ADMINISTRATIVE AMENDMENT (PD) ADD2026-00010

ADMINISTRATIVE APPROVAL
LEE COUNTY, FLORIDA

WHEREAS, RESPEC Company LLC filed an application for an administrative amendment to a Residential Planned Development (RPD) known as Homes at 81 West for property generally located along the east side of Blasingim Road and south of Penzance Boulevard, and more particularly described as follows:

PROJECT:
HOMES AT 81 WEST

Sheet Number: 1

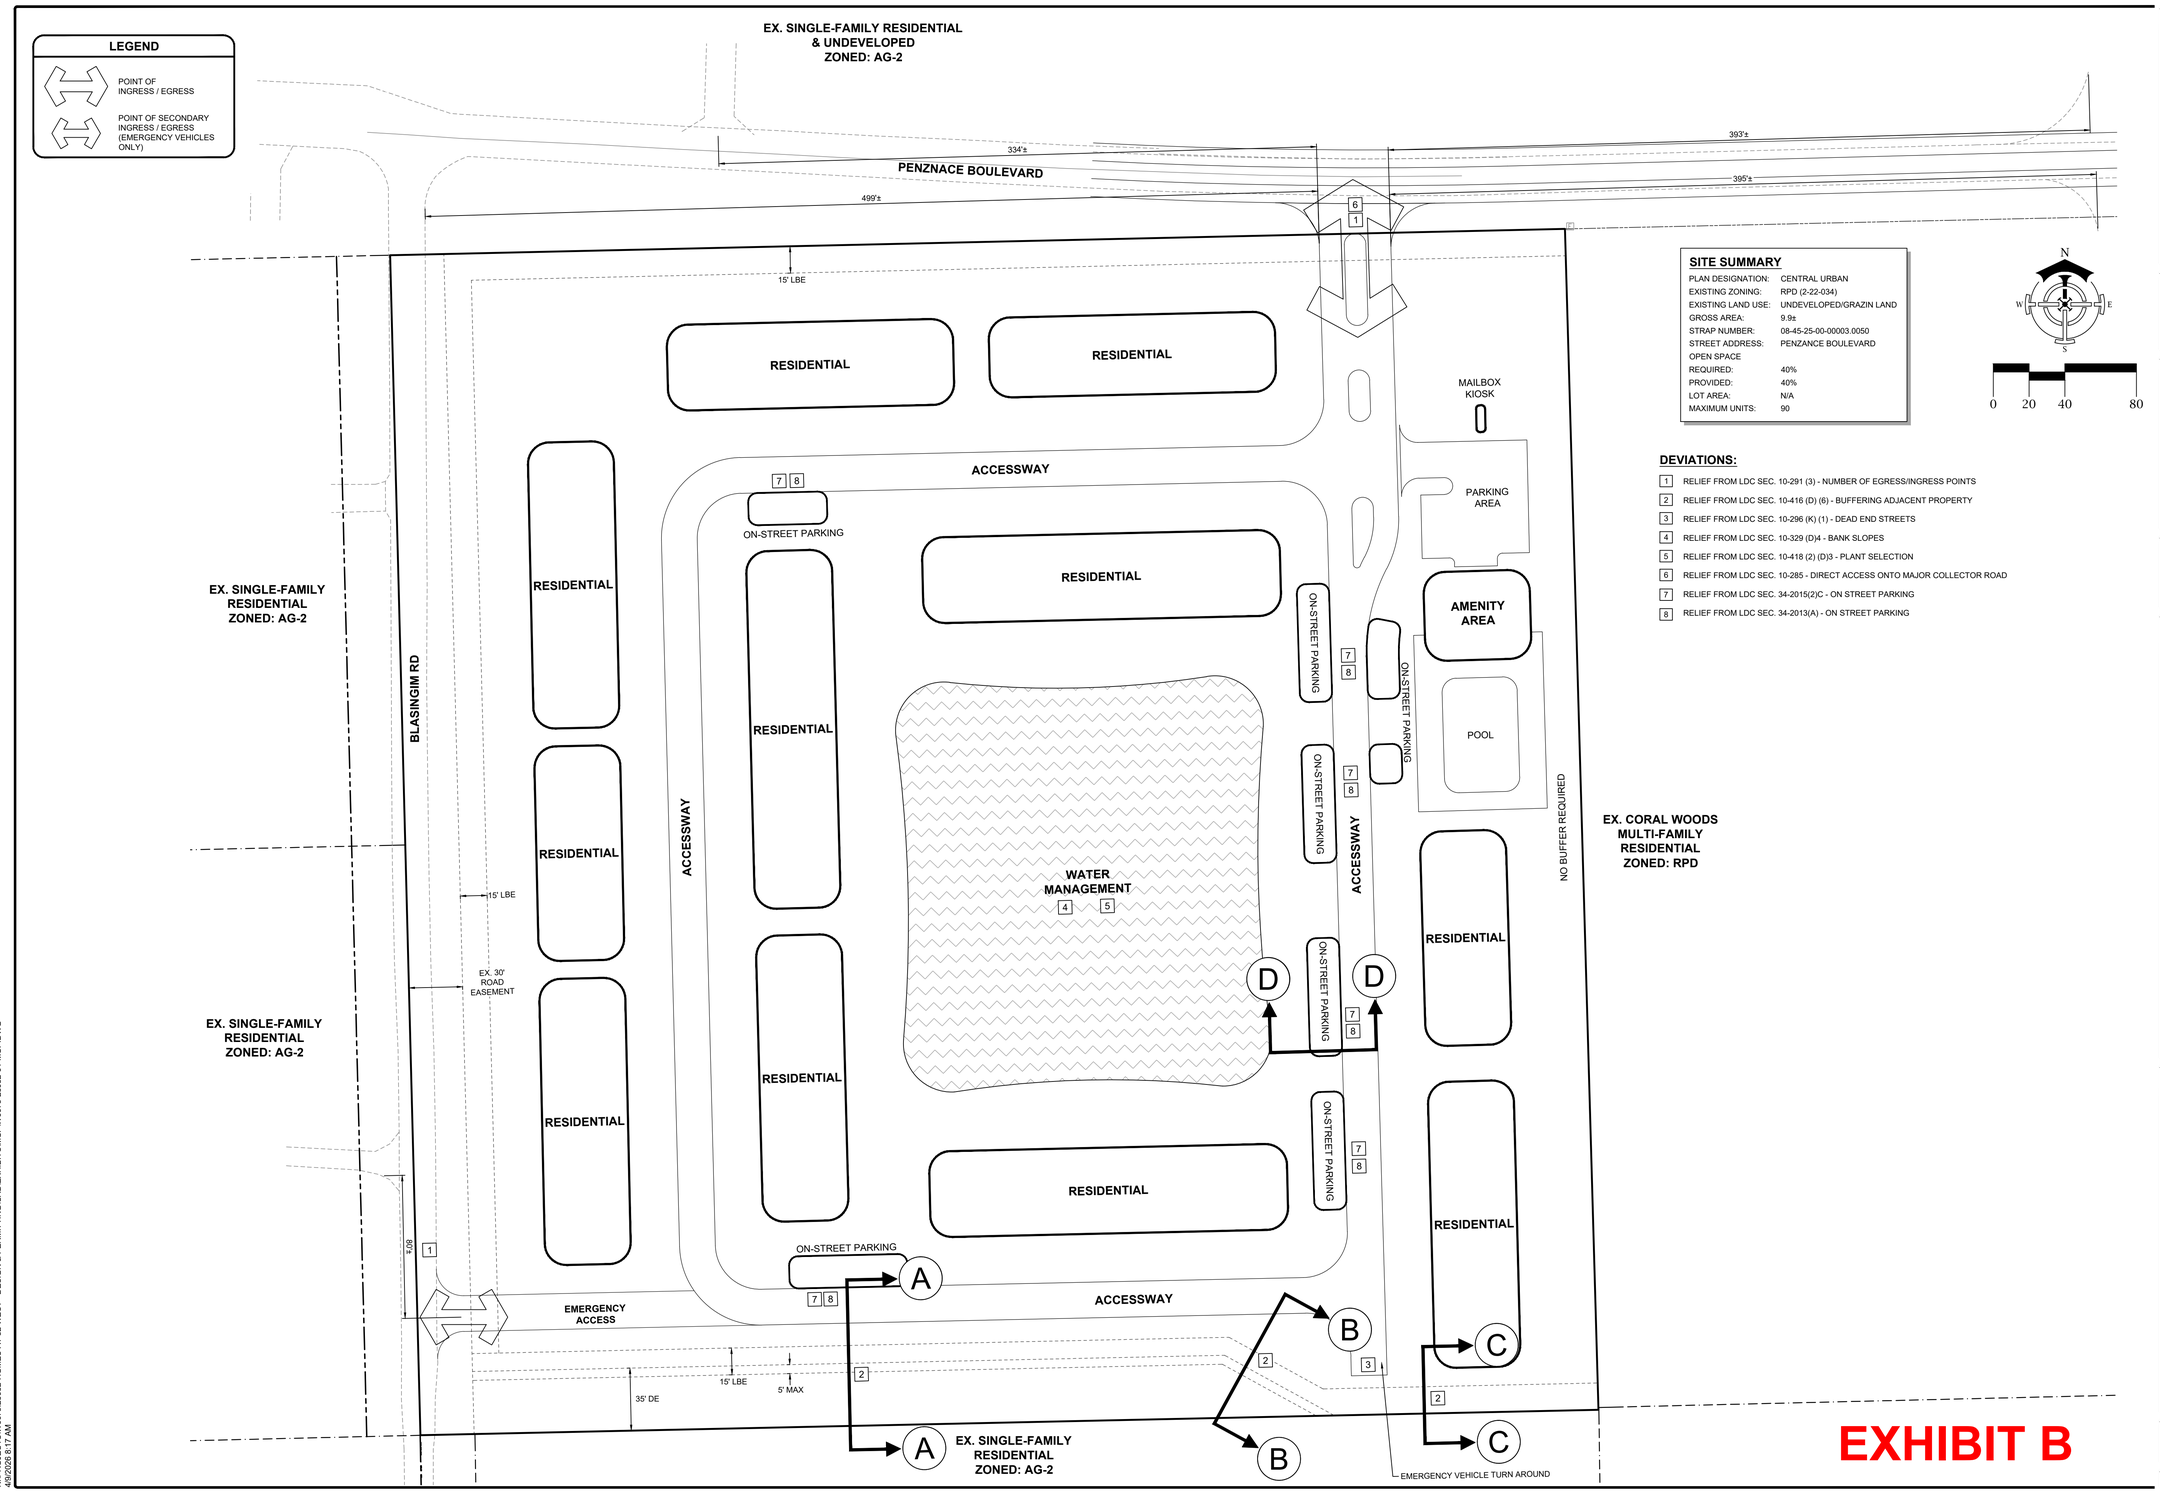
WHEREAS, the applicant now requests an additional amendment to the approved Master Concept Plan to revise the primary access configuration, rotate the amenity center and pool area within the approved amenity location, replace previously approved on-street amenity parking with a dedicated off-street parking area, and incorporate additional on-street parking throughout the internal roadway network (see Exhibits “B” and “C”); and

1. **Access Adjustment:** The primary access/driveway configuration has been revised from the alignment approved under ADD2025-00160, shifting back toward a configuration more consistent with the original MCP approved under Z-22-034.

2. **Amenity Center Rotation:** The previously approved amendment relocated the amenity center from the southern portion of the site to a location nearer the primary project entrance on the northern side of the property. This amendment rotates the amenity center building and pool area within the same general location near the northeast corner of the property.

3. **Amenity Parking:** Revised from the previous amendment to replace on-street parking with a dedicated off-street parking lot serving the amenity center and pool area.

4. **On-street Parking:** Revised to include on-street parking along each side of the roadway, as illustrated in the typical parking section. These spaces are intended to count toward the required parking per the Lee County Land Development Code.

1. **Development of the property must be consistent with the amended two-page Master Concept Plan entitled “Homes at 81 West Master Concept Plan,” prepared by RESPEC Company LLC, and attached hereto as Exhibit “B.”**

SECTION D-D
NTS

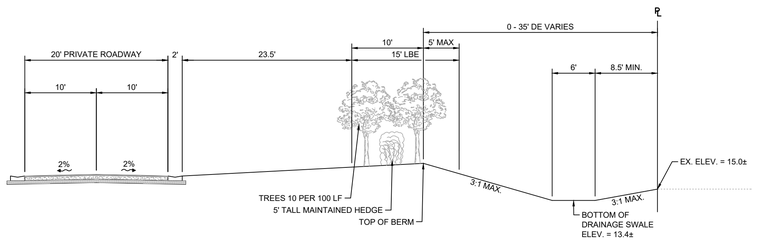
WHEREAS, Section “D-D” has been added to Sheet Number 2 of the revised Master Concept Plan to depict a typical on-street parking cross section associated with the proposed perpendicular on-street parking configuration within the internal roadway network (see Exhibit “B”); and

Deviation 7 seeks relief from LDC Section 34-2015(2)C., which requires individual parking spaces to be accessible from a parking aisle intended to provide access to the space, to allow perpendicular on-street parking that will be accessible from the internal roadway network.

Deviation 8 seeks relief from LDC Section 34-2013(a) requiring parking lots to be designed to permit vehicles exiting the parking lot to enter the street right-of-way or easement in a forward motion, to allow parking to back out into the right-of-way of the subject development.

3. **<u>Deviation # 7</u> from LDC Section 34-2015(2)c. to allow perpendicular on-street parking spaces accessible from the internal roadway system is hereby APPROVED, subject to compliance with Section “D-D” on Page 2 of the amended two-page Master Concept Plan, including the depicted roadway cross-section, parking configuration, and associated dimensional standards.**

4. **<u>Deviation # 8</u> from LDC Section 34-2013(a) to allow vehicles to back into the private roadway system from perpendicular on-street parking spaces is hereby APPROVED.**
